EC70139 REV. 0
ATTACHMENT Z51R0
DWG. NO. 522-041-009

NO.		DESCRIPTION		DRAWN
REVISIONS				
NUCLEAR ENGINEERING				
CRYSTAL RIVER UNIT 3				
AUXILIARY BUILDING - SOUTH STEEL FRAMING MODIFICATIONS DETAILS				
EWN DRAWN	MPB CHKD.	X APRVD.	12/9/10 DATE	NONE SCALE
C DISCP.	009 SHEET	DWG.	522-041	REV.

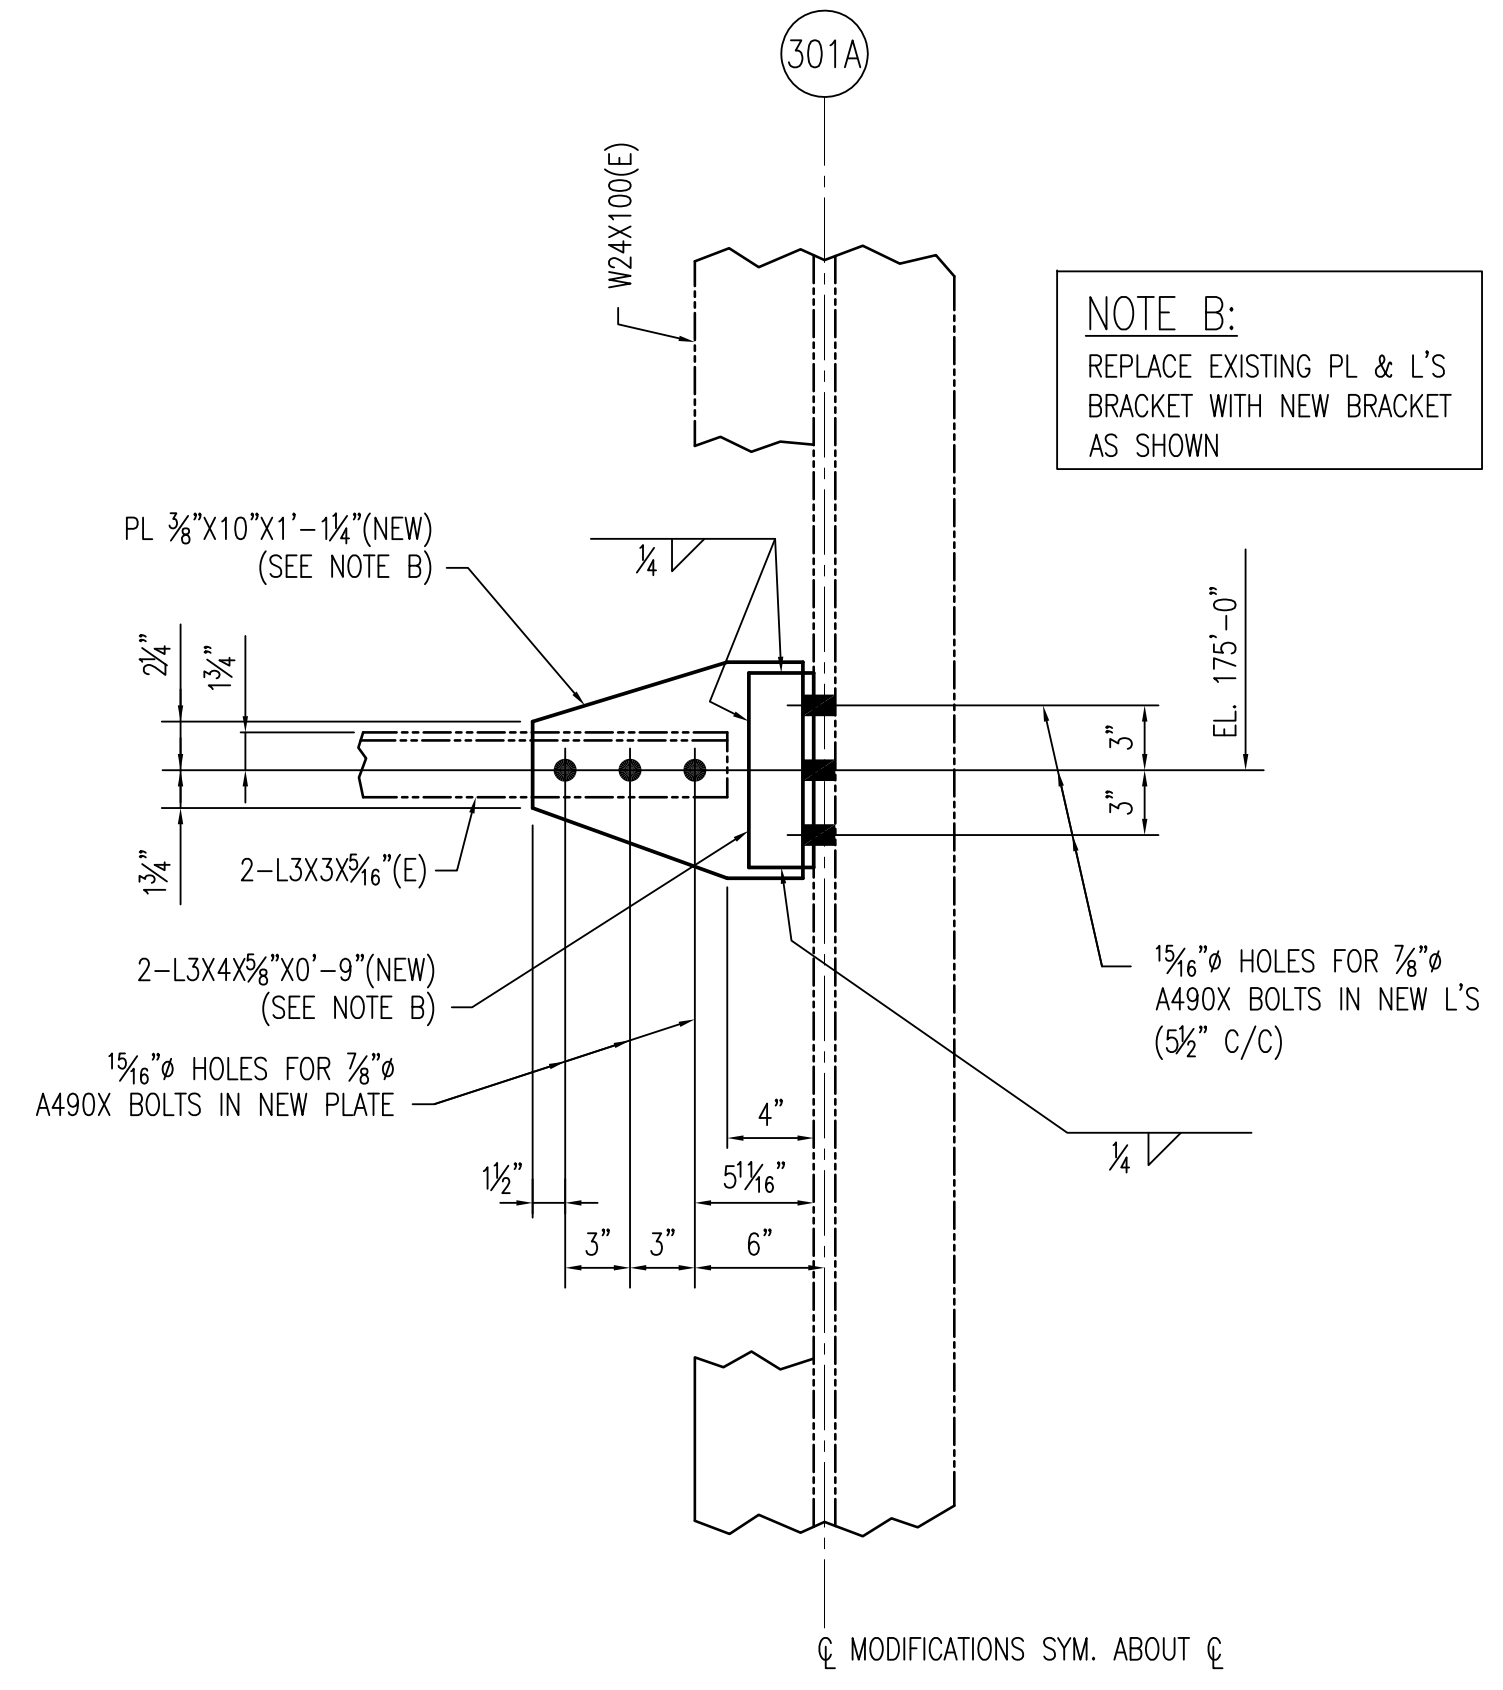
NOTE A:
REPLACE EXISTING W14
BRACKET WITH NEW PLATE
AS SHOWN.

NOTE B:
REPLACE EXISTING PL & L'S
BRACKET WITH NEW BRACKET
AS SHOWN
